Attachment B1

Selected Drawings

PROJECT
2235 BILLYARD 21C
DRAWN SENIOR QA APP'D
MP CM WS

DWG TITLE
LEGEND, DRAWING LIST, SITE MAP
DWG NO REV
DA000 J

1 ELEV WEST

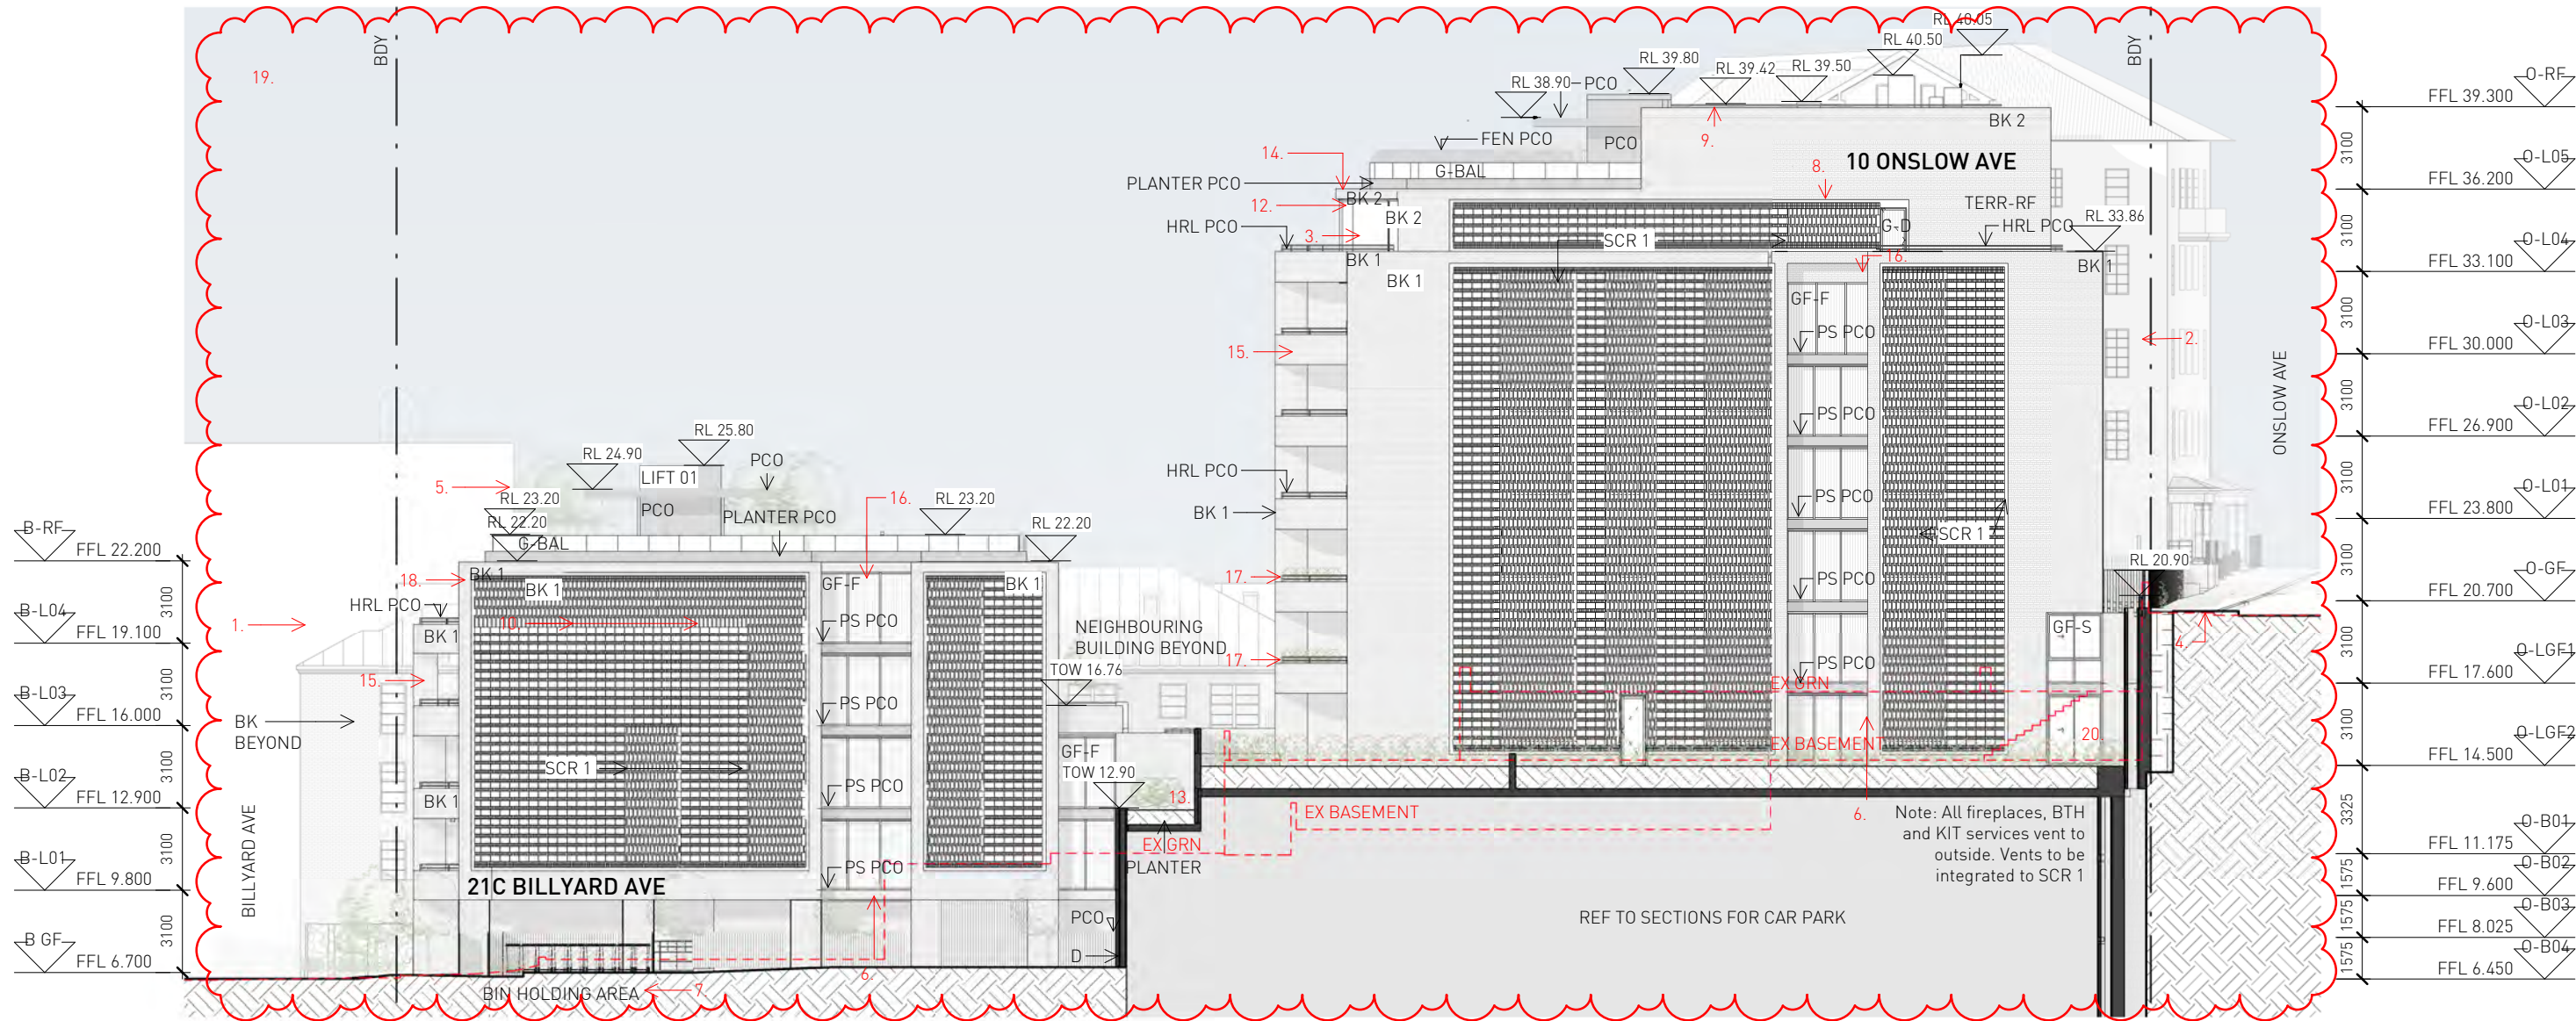
1. Billyard street setback increased by 1m.
2. Onslow street setback increased by 1.8m.
3. Upper form adjusted.
4. Planter extended.
5. Billyard Rooftop area allocated to communal open space. Private Penthouse Terrace removed. Shading structure added. Plant enclosure added.
6. Horizontal privacy screen added.
7. Permanent bin store moved to basement, temporary bin holding area along west boundary.
8. O-L04 terrace door relocated.
9. Side setbacks of Upper form increased. Lift access to the rooftop removed (lift terminates on L05. PTH TERR and Communal TERR with planter & G-BAL introduced on L05 after increasing northern form setback.
10. Deletion of screen and window
11. Sect Neighbouring BDY East removed. Refer to Sections H&I.
12. Top façade pushed back by 1m.
13. Planter dropped.

- DA ISSUE 07:
14. Onslow Penthouse splayed and curved for solar compliance to 12 Onslow
 15. Brickwork pattern updated.
 16. Glazing details updated.
- DA ISSUE 08:
17. Planter added to western balcony for visual privacy.
 18. Facade screen adjusted for bulk and scale.
- DA ISSUE 09:
19. Detailing of facades, brickwork, openings shown, including:
 20. Swing door replaced with sliding door and window.

1 SECT A

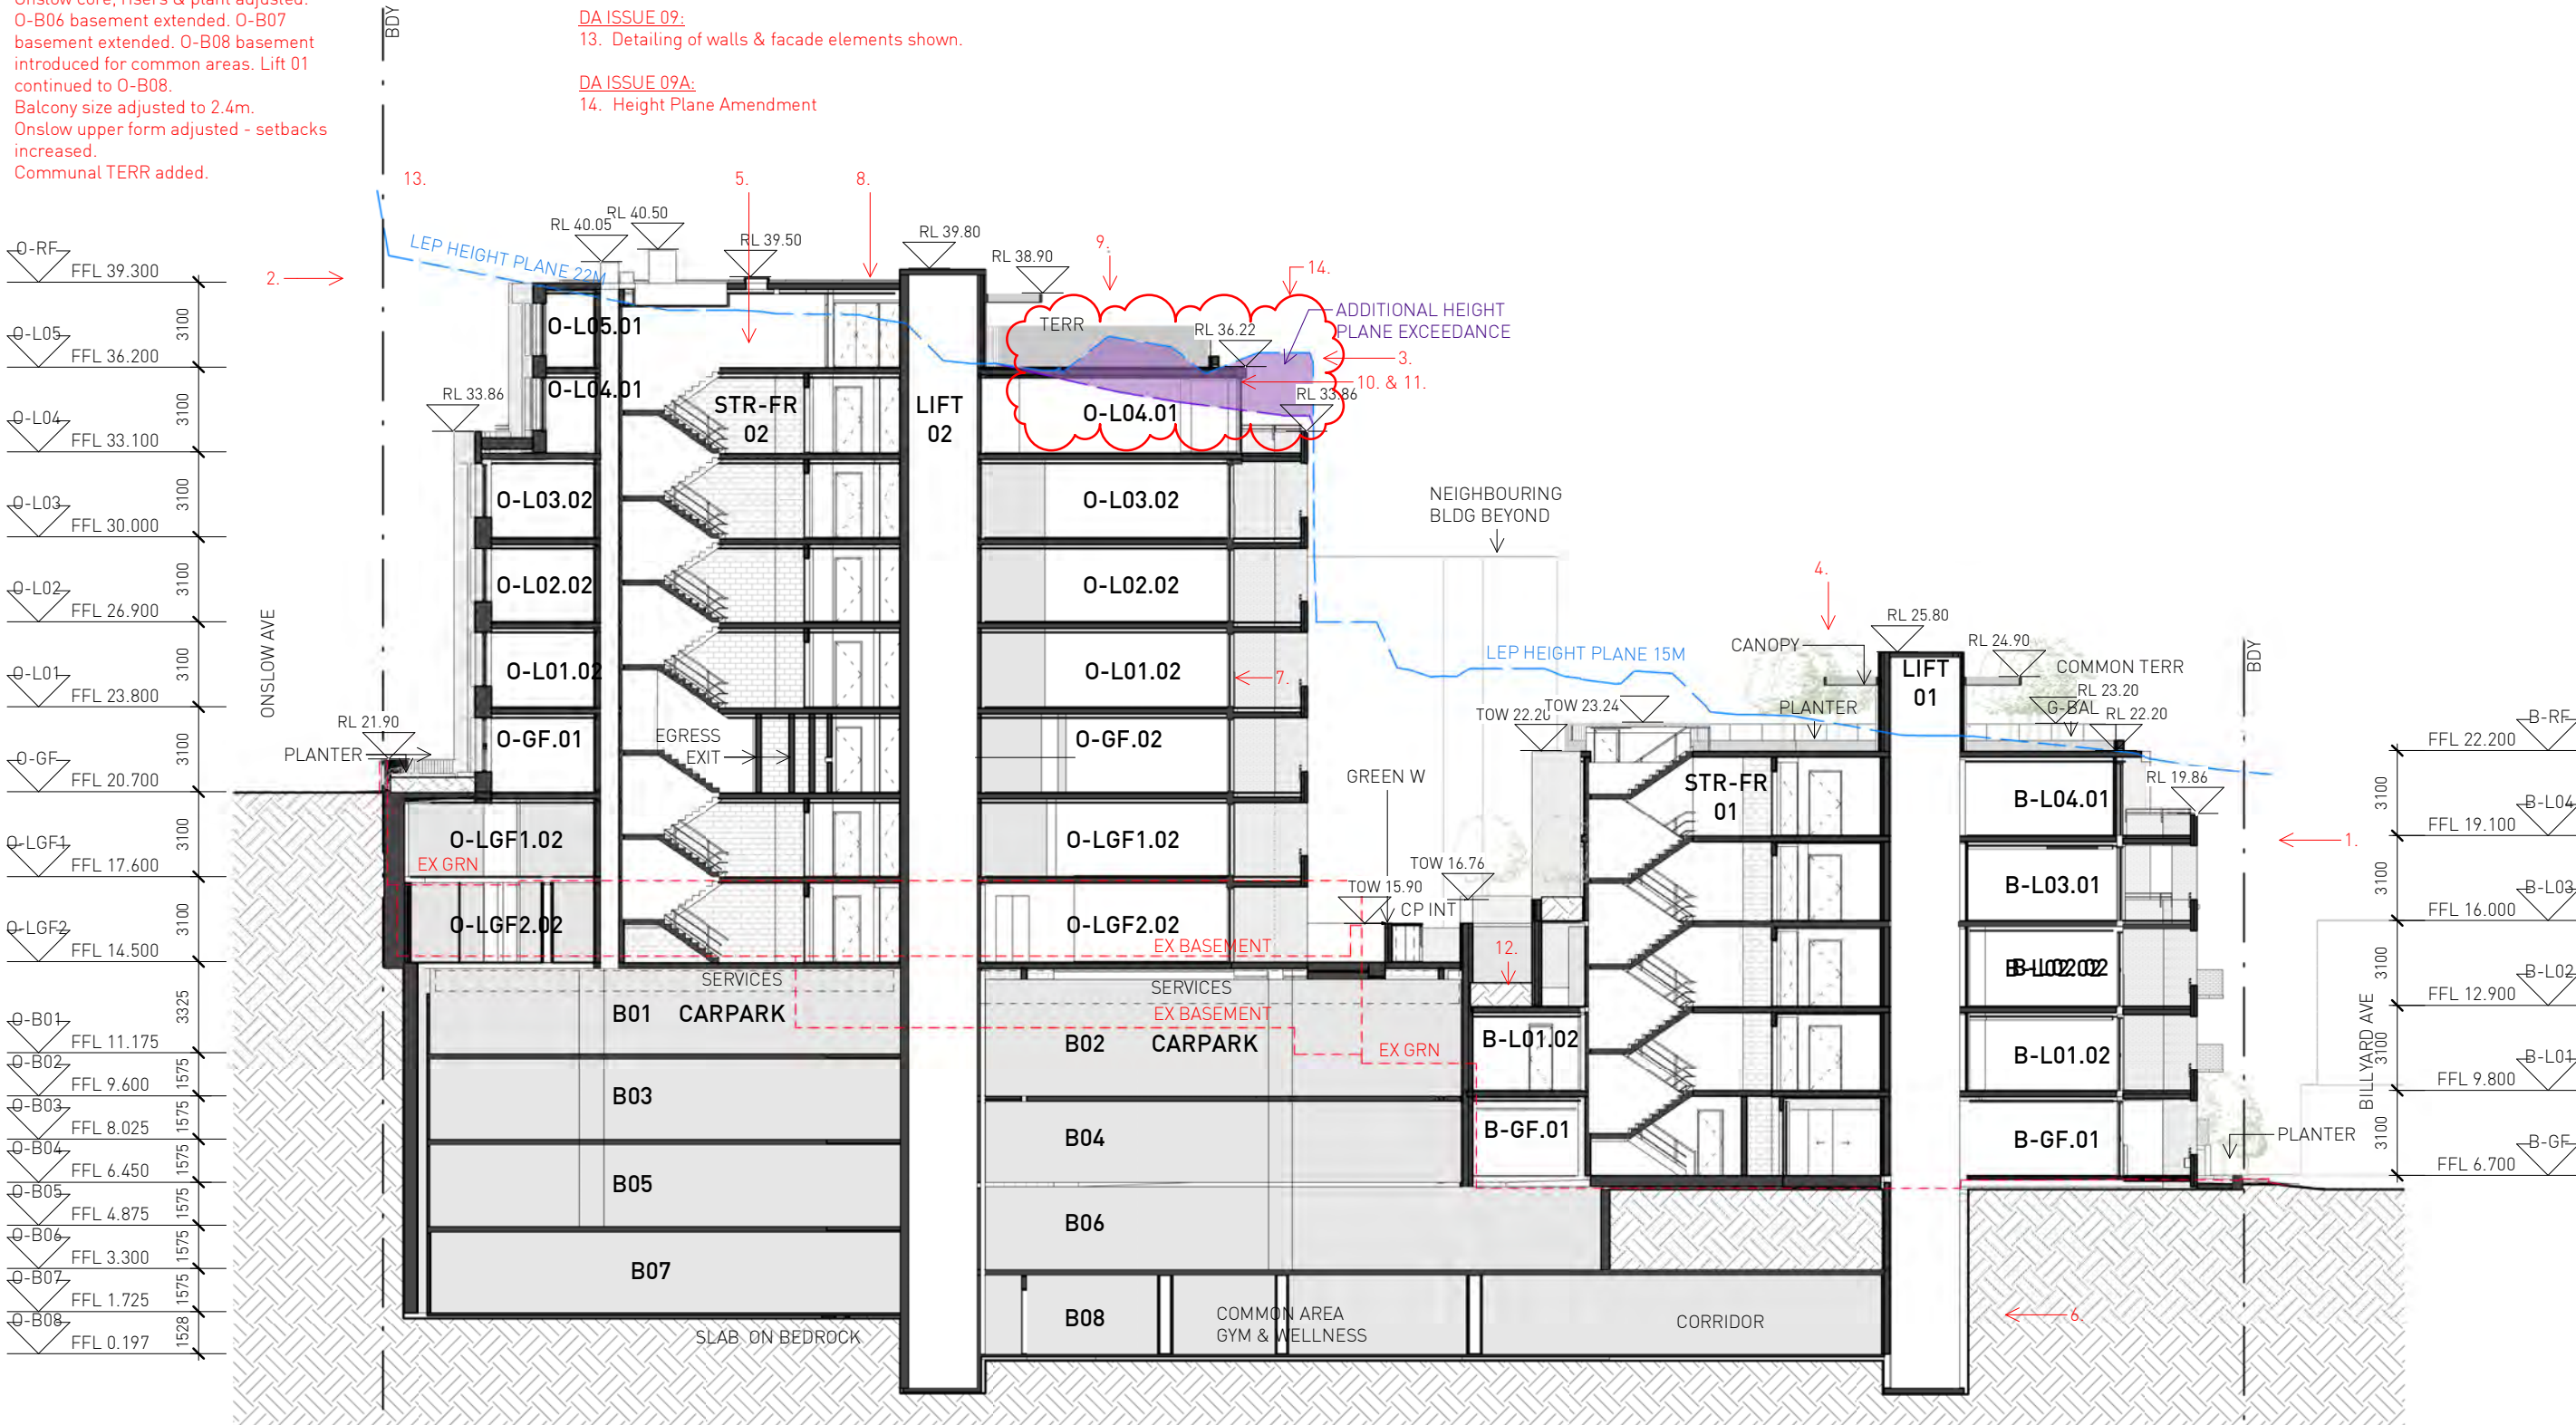
- 1. Billyard street setback increased by 1m.
- 2. Onslow street setback increased by 1.8m.
- 3. Height Plane & demarcation line adjusted.
- 4. Billyard Rooftop area allocated to communal open space. Private Penthouse Terrace removed. Shading structure added. Plant enclosure added.
- 5. Onslow core, risers & plant adjusted.
- 6. O-B06 basement extended. O-B07 basement extended. O-B08 basement introduced for common areas. Lift 01 continued to O-B08.
- 7. Balcony size adjusted to 2.4m.
- 8. Onslow upper form adjusted - setbacks increased.
- 9. Communal TERR added.

- DA ISSUE 07:
- 10. Further cut backs to Onslow for solar compliance to 12 Onslow.
 - 11. Onslow Penthouse splayed and curved for solar compliance to 12 Onslow.
 - 12. Back of Billyard pushed down for solar compliance to 23 Billyard.
- DA ISSUE 09:
- 13. Detailing of walls & facade elements shown.
- DA ISSUE 09A:
- 14. Height Plane Amendment

1 SECT D

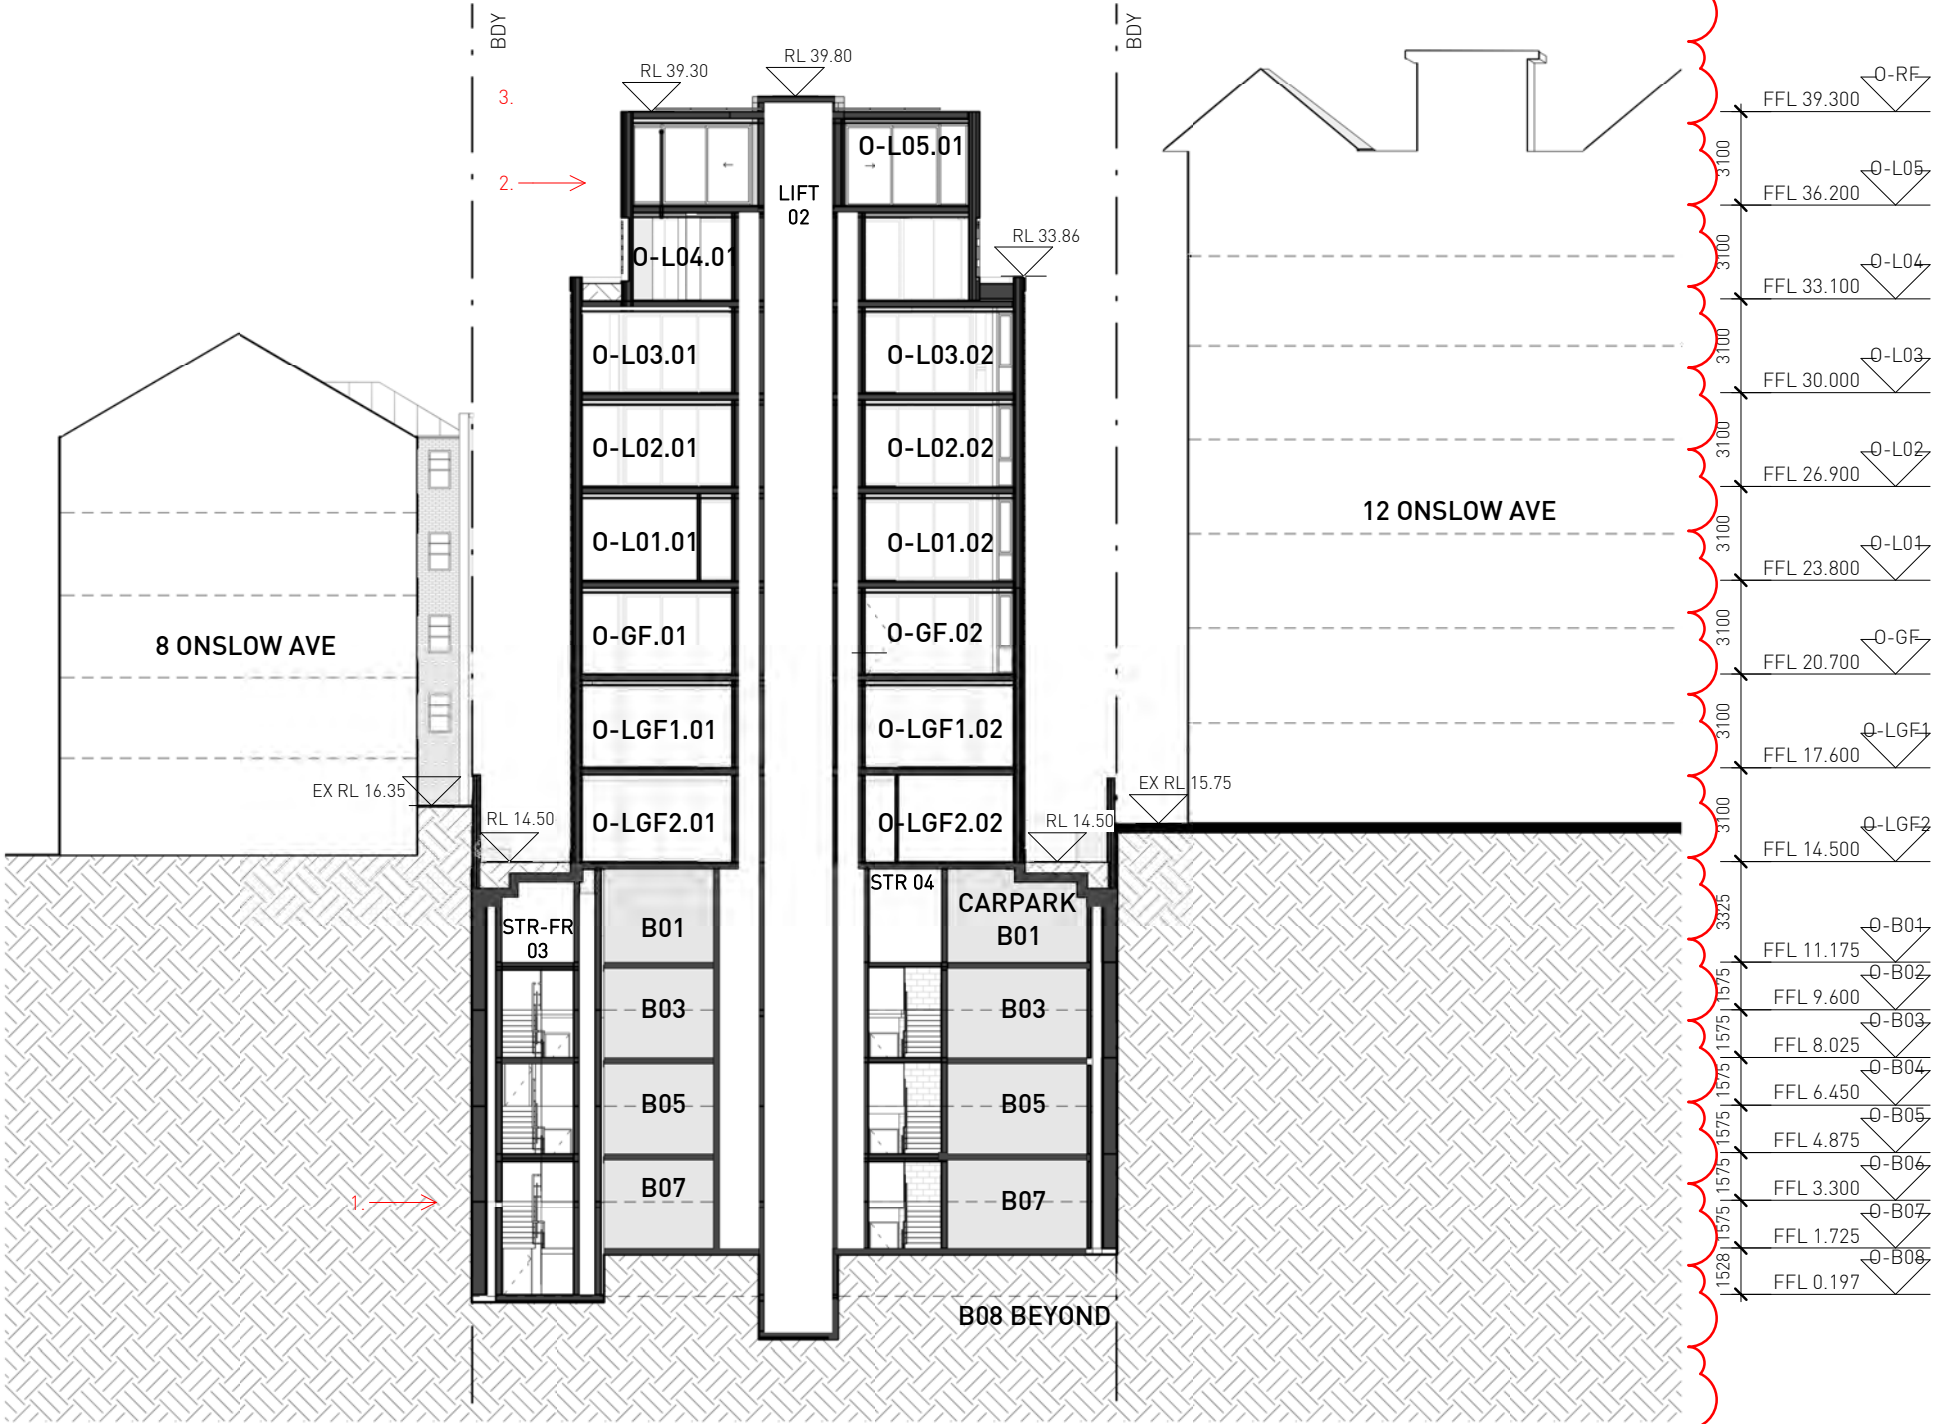
1. O-B06 basement extended. O-B07 basement extended. O-B08 basement introduced for common areas. Lift 01 continued to O-B08.
2. Top setbacks increased.

DA ISSUE 09:
3. Detailing of walls & facade elements shown.
